Subject: Modine e-fan Harness Rework			
Field Change Program: Field Campaign	FCP Number: 480	Revision: A	Date: 07/21/2020
Coach Section: 06-Cooling	P/N: 06-01-1648, 06-01-1655		Type: Product Integrity

1.0 Description

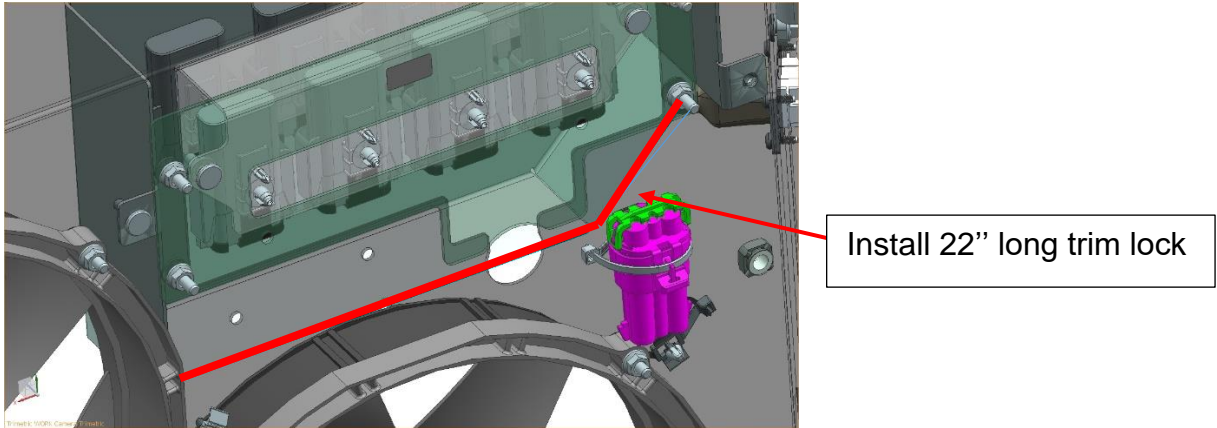
Install the 22" long trim lock, MCI P/N: 6482600, along the inside edge of the fuse compartment shown below.

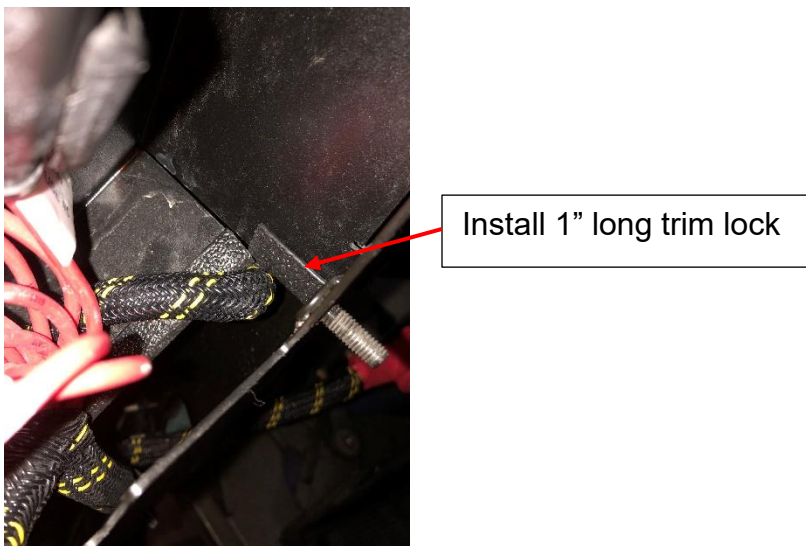
Install the 1" long trim lock, MCI P/N: 6482601, along the RH shorter edge of the fuse compartment, as shown below.

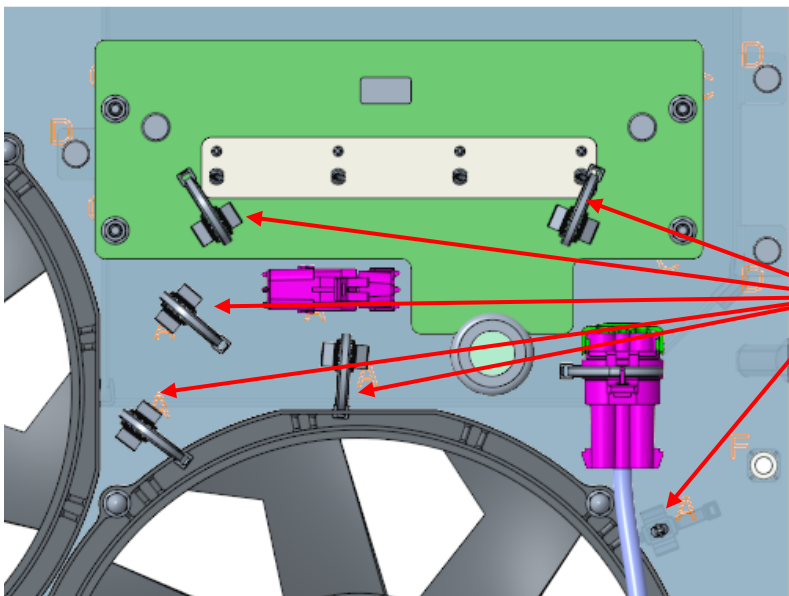
Install the tie bases, MCI P/N: 6482602, at the location shown below and secure the harness.

Install the tie bases and secure the harness

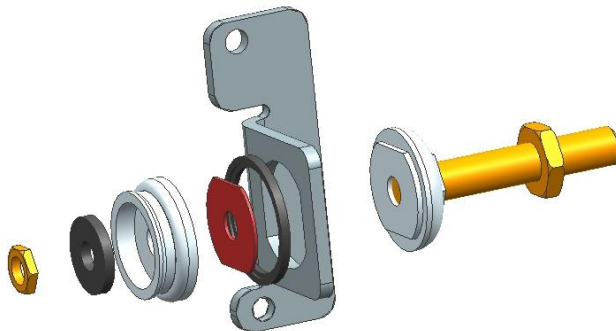
Install the components saved in the previous step to the new power stud bracket, MCI P/N: 6482599, in the order shown below. Torque the jam nut to 18.5 Ft-Lbs.

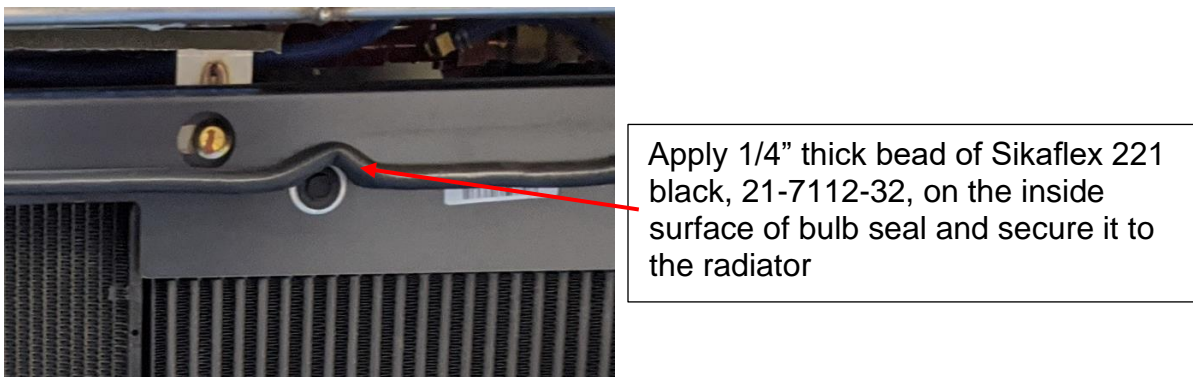
Apply 1/4" thick bead of Sikaflex 221 black, MCI P/N: 21-7112-32, on the inside surface of bulb seal and secure it back to the radiator.
